**Review of  
Blasting Attenuation Study,  
Structure Response Study,  
Proposed Blasting Ordinance and  
Current Blasting Ordinance,**

**August 12, 2005**

**Prepared for the  
City of Henderson, NV**

**Prepared by:  
Larry Schneider P.E.**

PPV vs Scaled Distance - Henderson, NV Ground Vibration Data

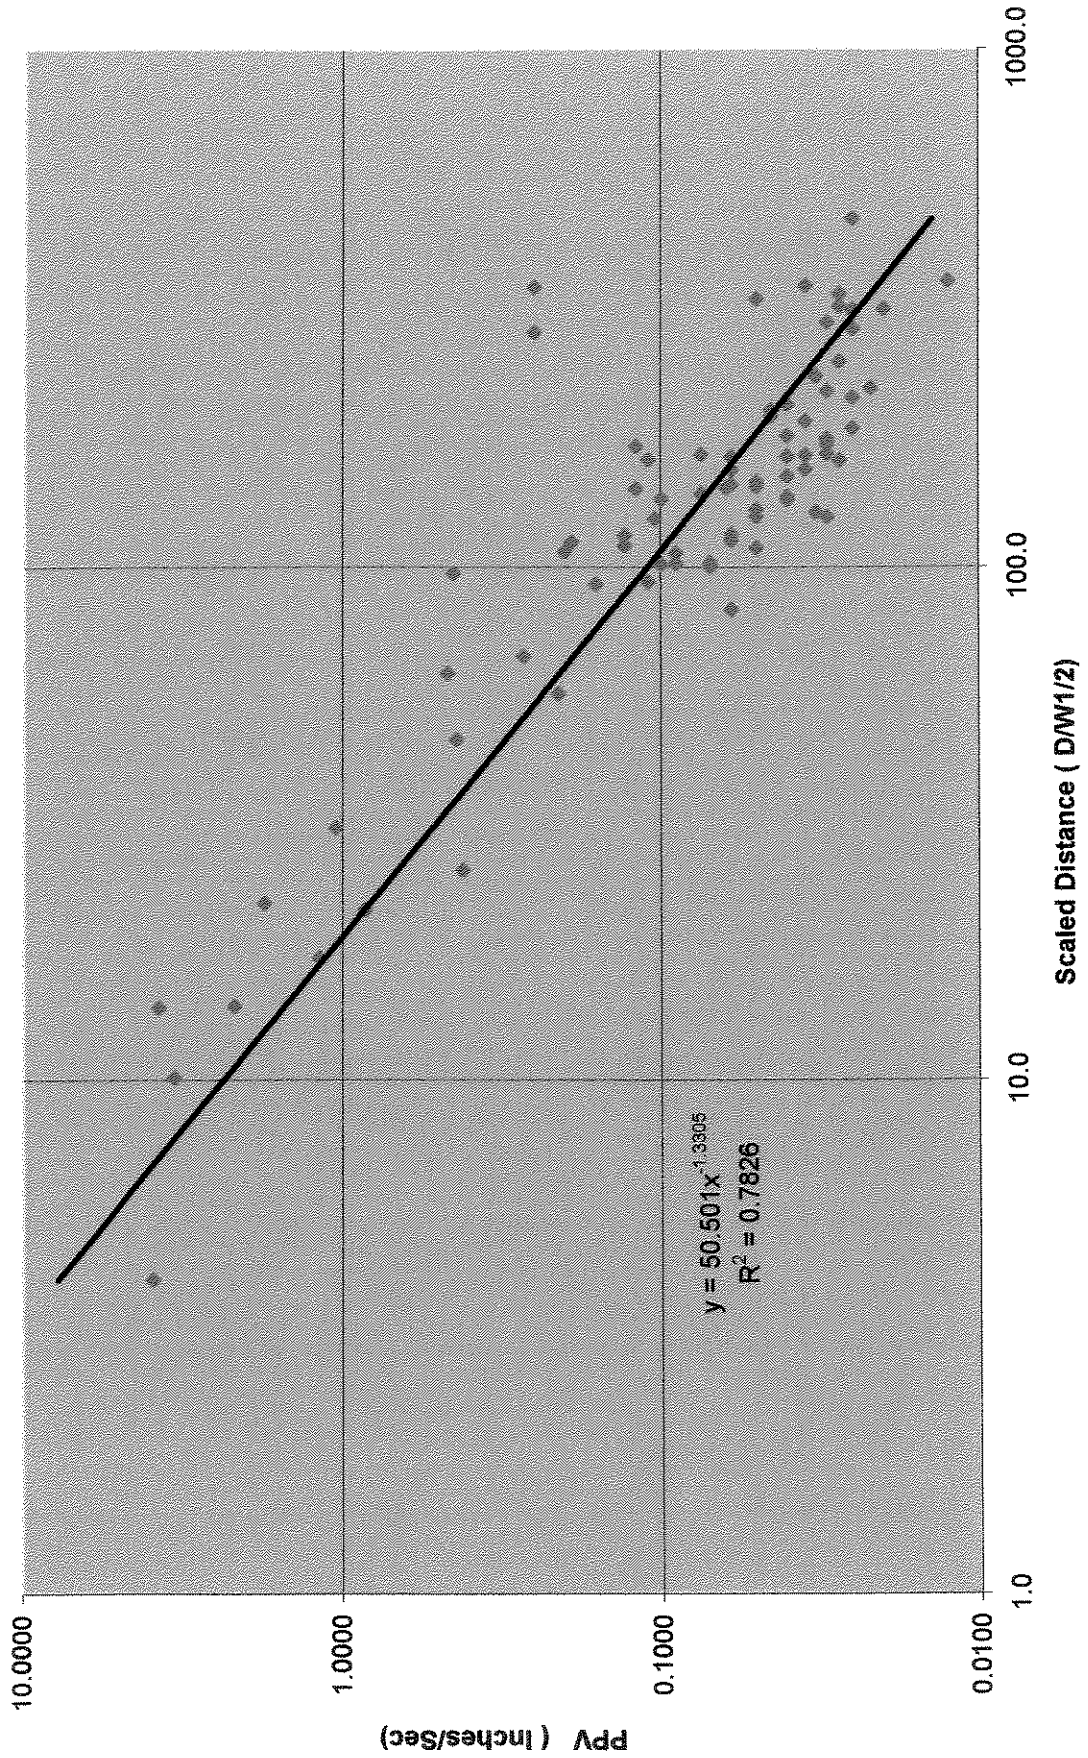
To confirm the results of the attenuation study, I used the data points listed in the Appendix of the Aimone-Martin report to plot several regression models, which are included as attachments to this report. Dr. Aimone-Martin found best fit equations for a number of different data sets, which she describes in detail, and from which she draws conclusions. My regression plots produced different equations and correlation coefficients, but these differences in these values are due to the fact that I plotted all the raw data contained in the appendix, whereas the Aimone-Martin report drew the regression line through only data points for which they had verifiable charge weight and distance values and discarded questionable seismic data.

Without access to the actual seismic waveforms, I could not make such distinctions and there are some obviously problematic data points contained in the appendix. For example, a recording on 4/12/2005 showing a PPV of 0.25 in/sec at a scaled distance of  $648.4 \text{ ft/lb}^{1/2}$  is highly improbable.

However, even a casual comparison of the regression plots in this report to the ones in the Aimone-Martin study should make it clear that the relationship between peak particle velocity and scaled distance is sufficiently well documented to support the conclusions made in the study. This is particularly obvious in the assessment that the fit of the data closely correlates the peak particle velocity to scaled distance in a manner comparable to that found in the Bureau of Mines research. This research is generally accepted to be the standard in this country.

# Henderson Nevada Data Air Blast Cube Root Scaling

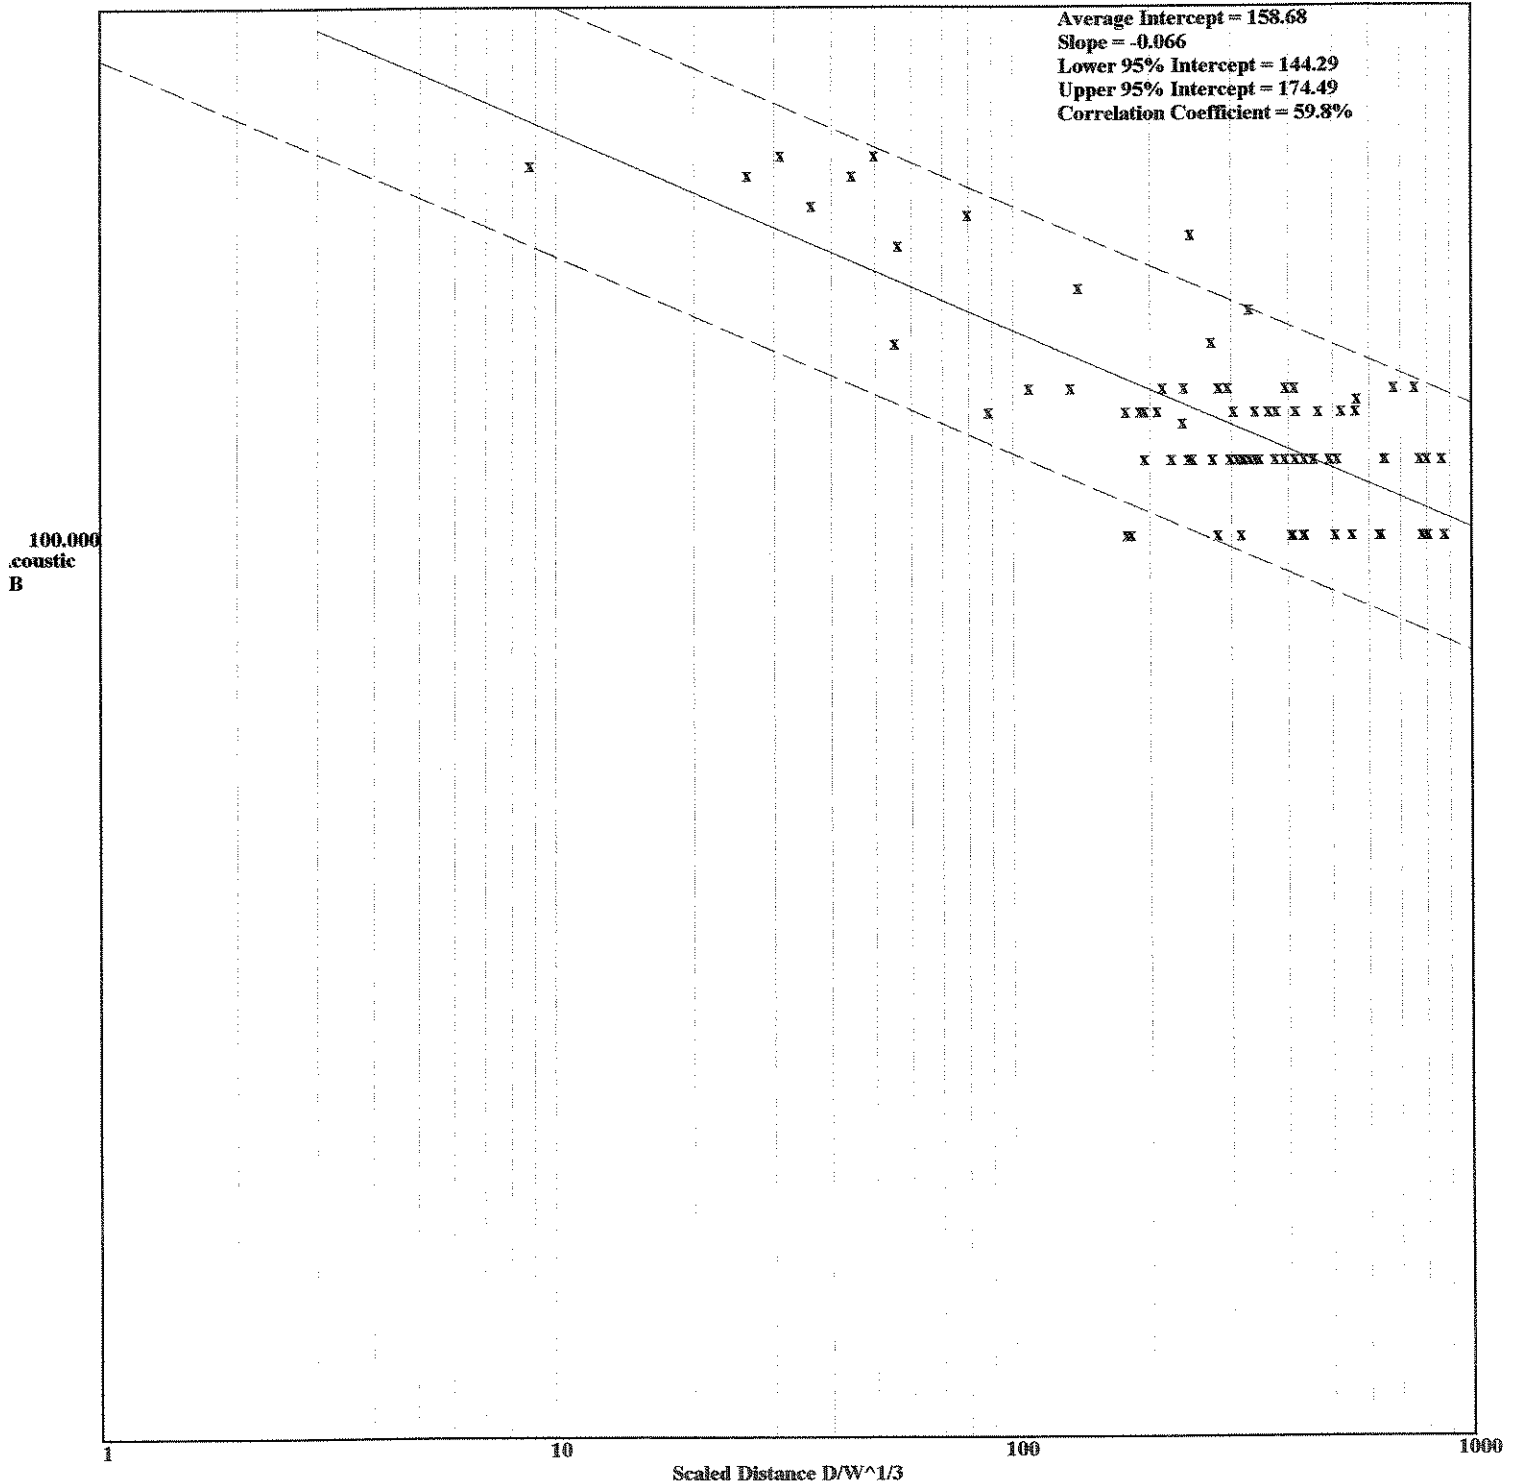
Using the airblast data contained in the appendix, I similarly plotted all data points on a graph attached to this report. The intensity of the air blast as measured in decibels was plotted against a cubed root scaled distance. As before there are differences in the equation's intercepts and slopes in my analysis and the Aimone-Martin plots. However, these differences are again due to the fact that Dr. Aimone-Martin was able to eliminate the questionable data points and use only verifiable readings. Both airblast regression plots show the clear trend of airblast intensity as a function of cube root scaled distance. The plots also plainly show that air blast data is subject to a great deal more scatter than ground vibration data due to atmospheric variables. This is very normal as all plots of airblast data will show significant scatter due to these effects.
